**GRID CODE
CONSULTATION DOCUMENT**

Frequency Response Requirements

Consultation Ref	D/07
Issue	1.0
Date of Issue	2 nd August 2007
Responses required by	31st August 2007
Prepared by	National Grid

Figure CC.A.3.2 - Interpretation of Primary and Secondary Response Values

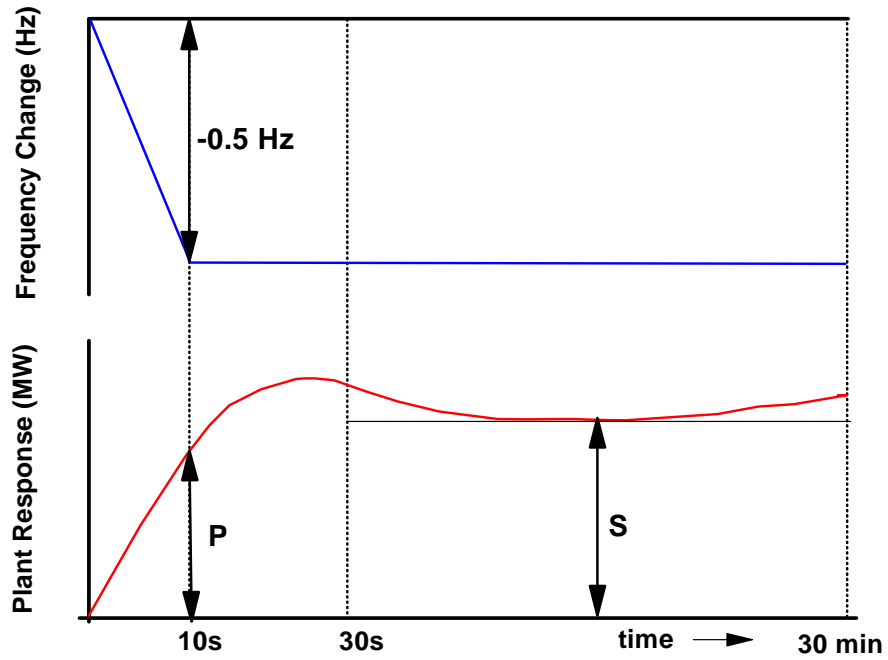
10.1 Based on discussions at the GCRP and subsequent comments, the profile of the frequency response over the period 0 to 10 seconds also needs clarification in wording in addition to the profile shown in Figure CC.A.3.2. Also, comments have been received that confusion arises from the final statement in CC.A.3.1 that the response requirements are defined diagrammatically in CC.A.3.2 and CC.A.3.3 when it has not been made clear that these diagrams are based on test signals.

- specifying that, as a minimum, the response should be linear when referring to the response required in both CC.A.3.4 and the Glossary and Definitions
- changing the reference in CC.A.3.1 to CC.A.3.4., in which the diagrams of CC.A.3.2 and CC.A.3.3 are explained, rather than directly to the figures of CC.A.3.2. and CC.A.3.3.

The **Primary Response** capability (P) of a **Generating Unit** or a **CCGT Module** or **Power Park Module** or **DC Converter** is the minimum increase in **Active Power** output between 10 and 30 seconds after the start of the ramp injection as illustrated diagrammatically in Figure CC.A.3.2. As a minimum, this increase in **Active Power** output should be

released linearly with time over the period 0 to 10 seconds from the time of the start of the **Frequency** fall as illustrated by the Plant Response in Figure CC.A.3.2. If there is an initial inherent delay in the increase of **Active Power** output following a **Frequency** fall, this must be minimised as far as is reasonably practicable and in any event such a delay should be no longer than two seconds unless in NGET's reasonable opinion a longer delay is unavoidable.

The **Secondary Response** capability (S) of a **Generating Unit** or a **CCGT Module** or **Power Park Module** or **DC Converter** is the minimum increase in **Active Power** output between 30 seconds and 30 minutes after the start of the ramp injection as illustrated diagrammatically in Figure CC.A.3.2.
